**LEBANON PLANNING BOARD  
MARCH 8, 2021 - 6:30 PM  
REMOTE VIA MICROSOFT TEAMS  
LEBANONNH.GOV/LIVE**

**Agenda  
Planning Board  
March 8, 2021**

Staff Memorandum – PB2021-02-EXT – *continued from 2/8/21*

EXISTING CONDITONS & DEMOLITION PLAN FOR  
**OCCOM PATH - BASIC HOLDINGS, LLC**  
OAK RIDGE ROAD, CITY OF LEBANON, GRAFTON COUNTY, NH

UTILITY PLAN

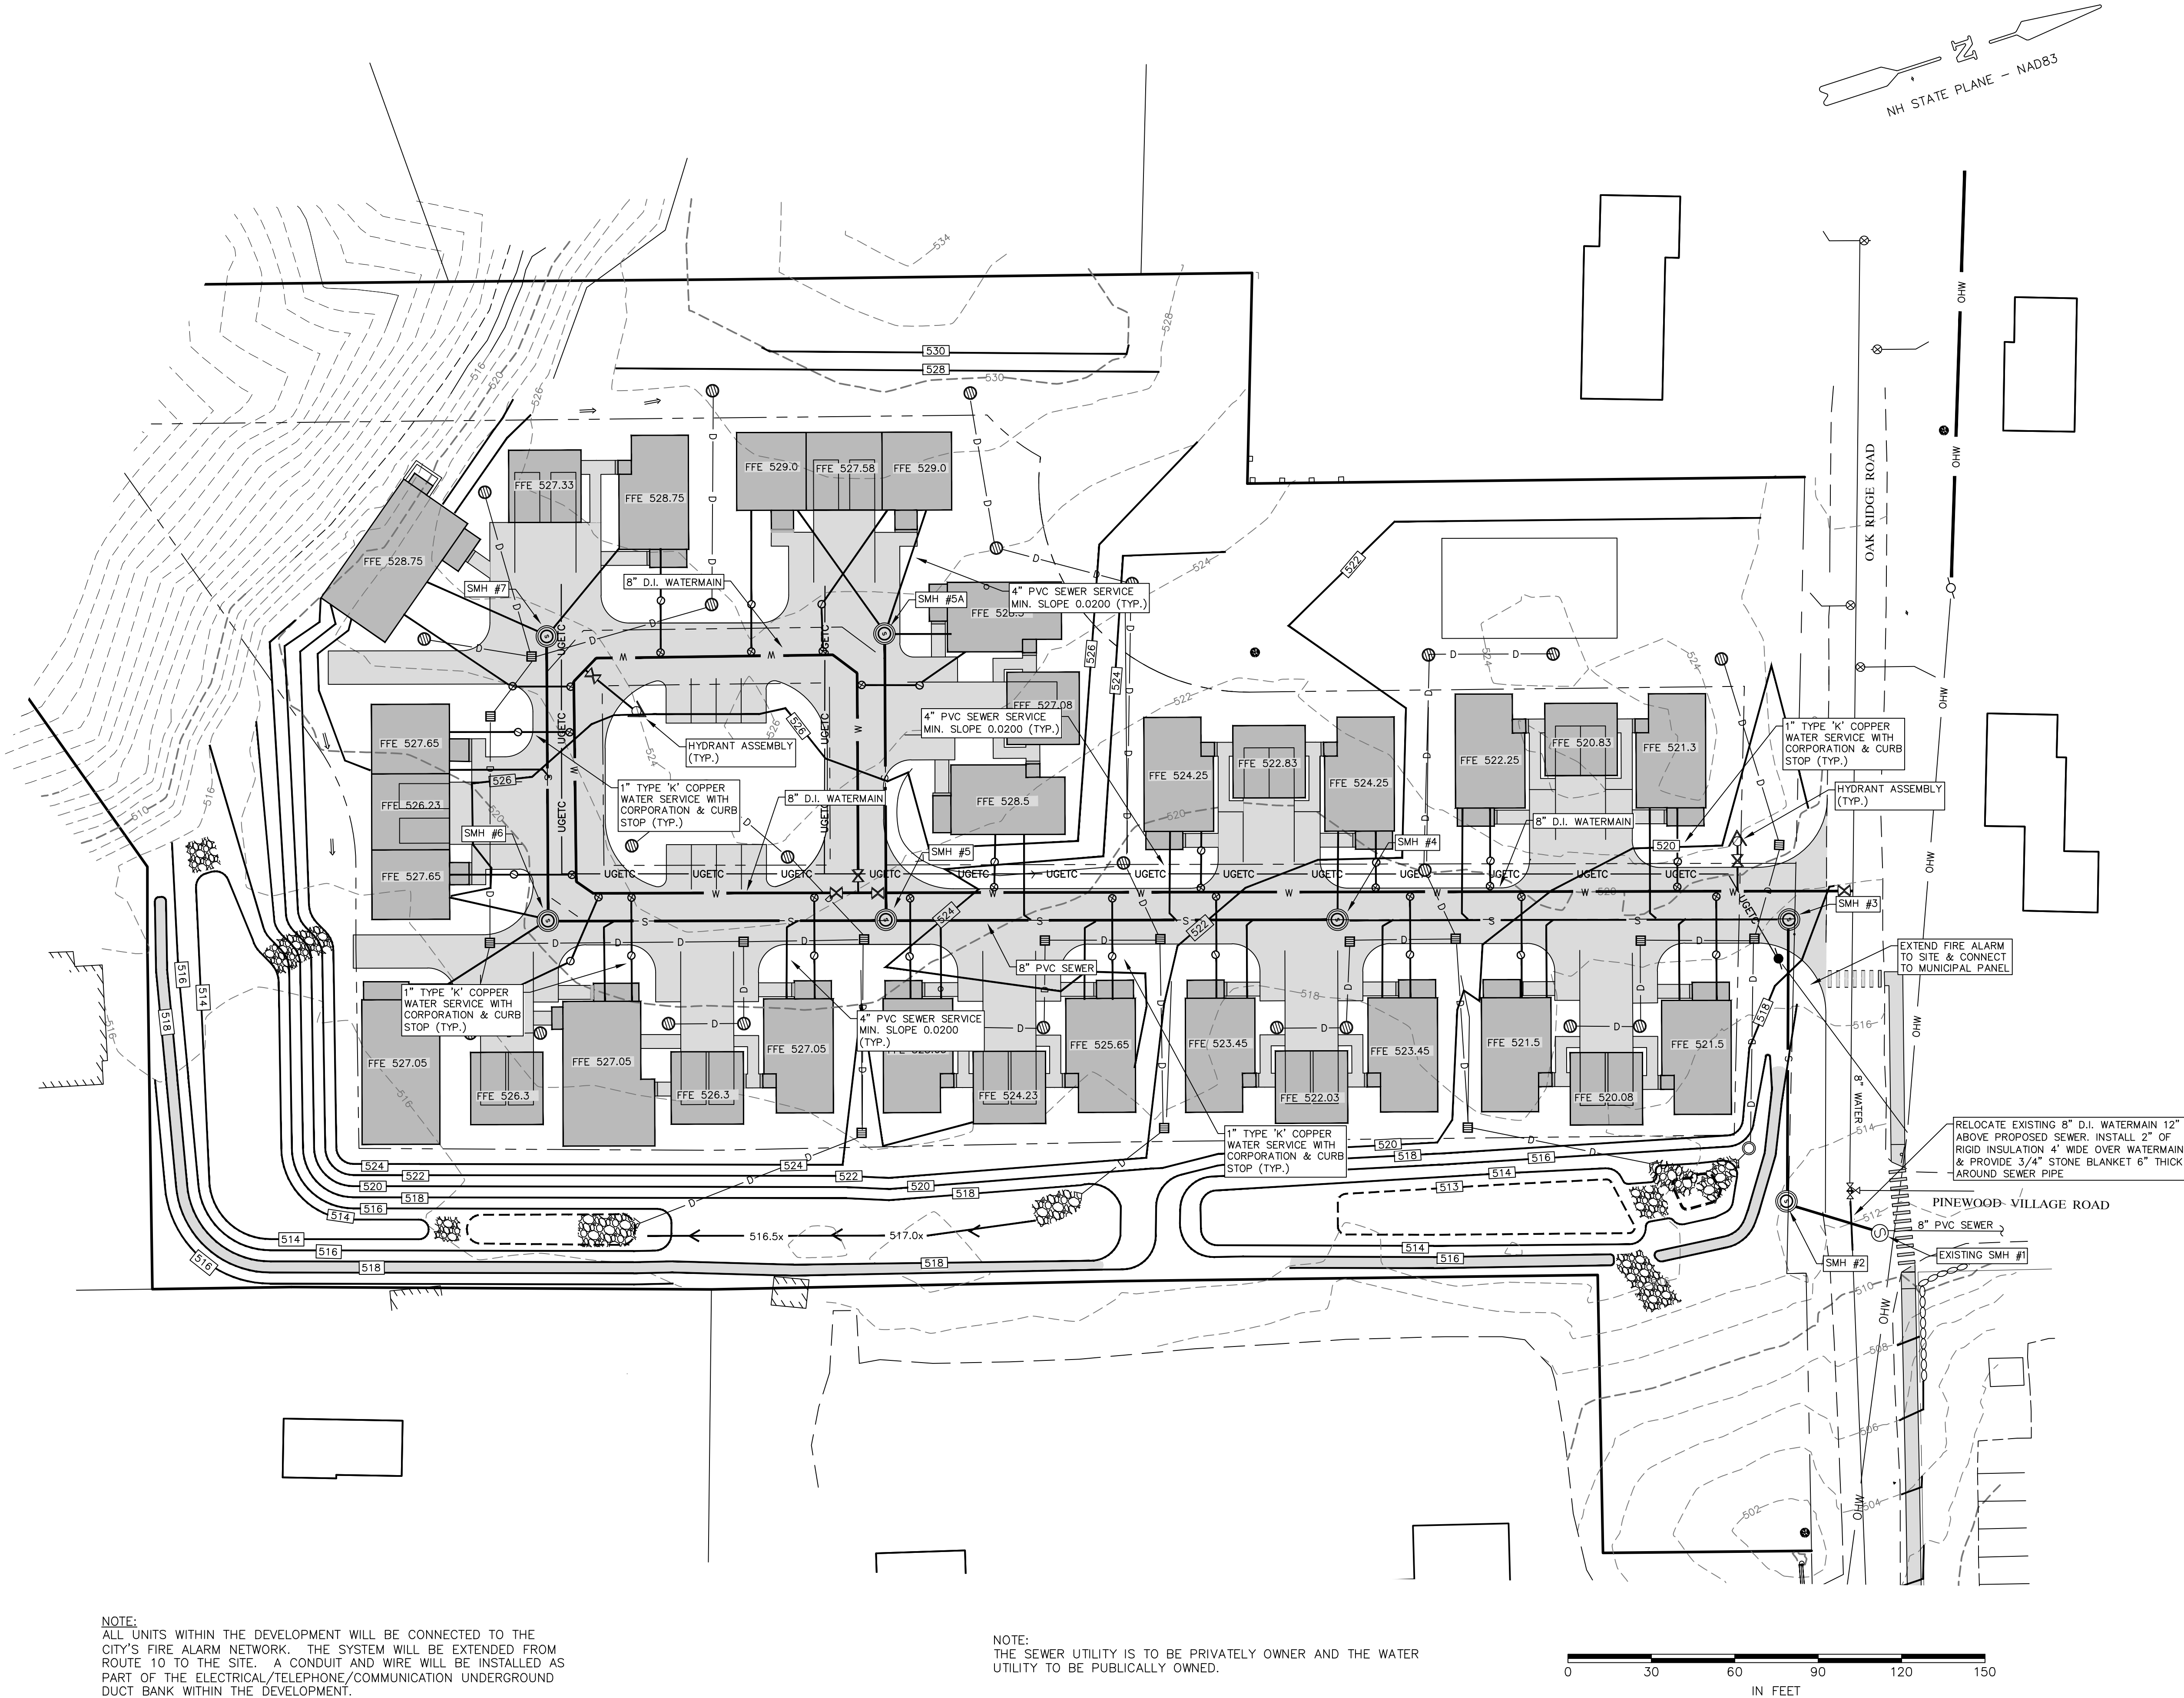
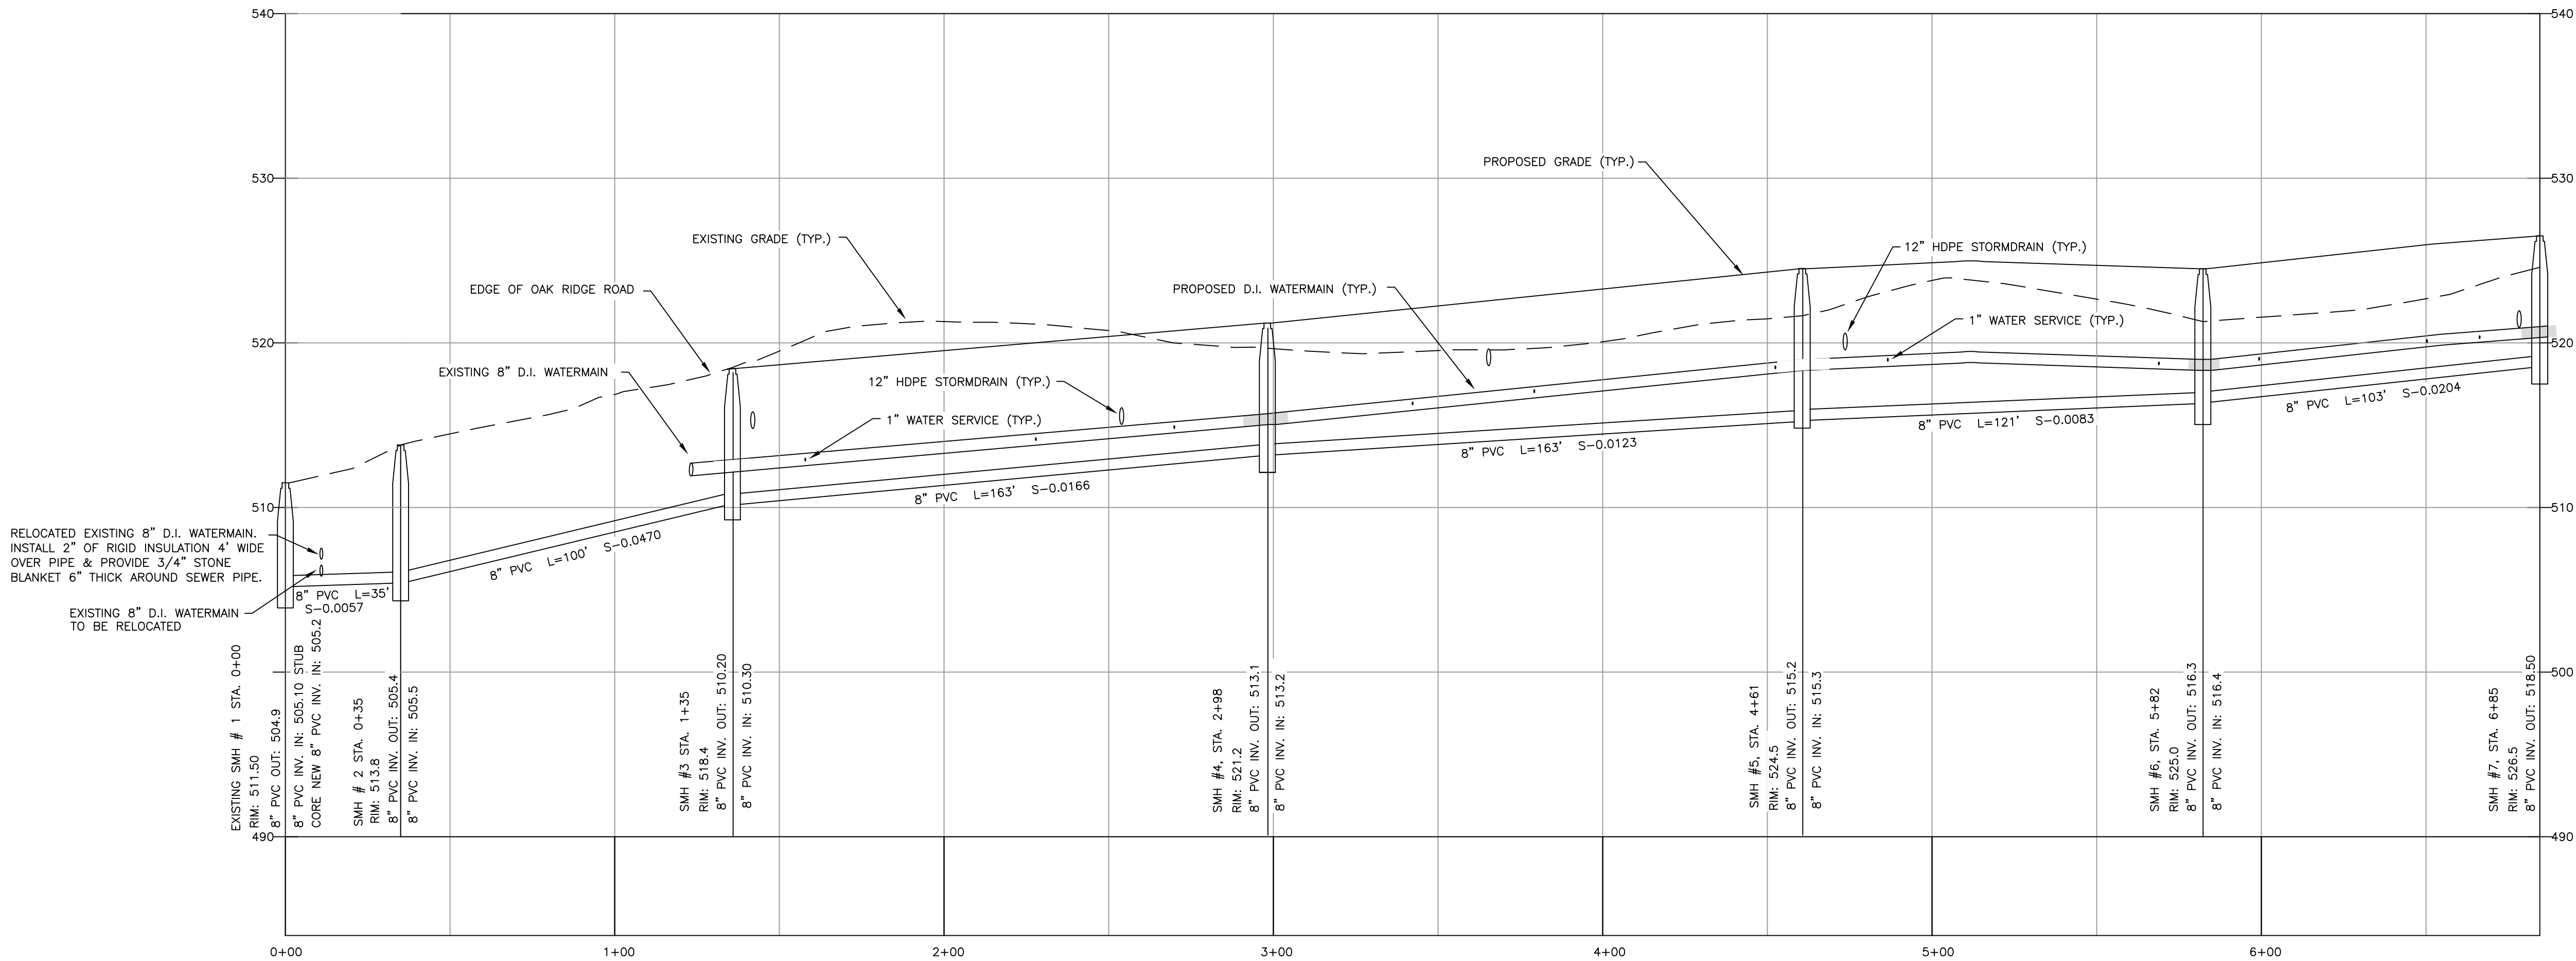
- v. Add any other information necessary to prepare the sheet for recording.
  - e) Add a plan note to Sheet 8 (utilities plan) indicating that underground utilities, electric, telephone and cable, must maintain a minimum clearance of 10 ft. from all proposed water lines.

- Based on sewer design invert values for SMH #4 specified on Sheet 8 it appears the design depth of that segment of proposed sewer situated between SMH #4A and SMH #4 will be insufficient to satisfy minimum burial depth and vertical separation requirement in the vicinity of an adjacent crossing and water and sewer mains.

- Based on design elevations specified on Sheet 8 it appears less than the required minimum of 6 feet of soil cover will be available in the vicinity of SMH #5.

- Although sewer profile information provided on Sheet 8 is properly stationed, corresponding stationing has not been provided on corresponding plan view drawings.
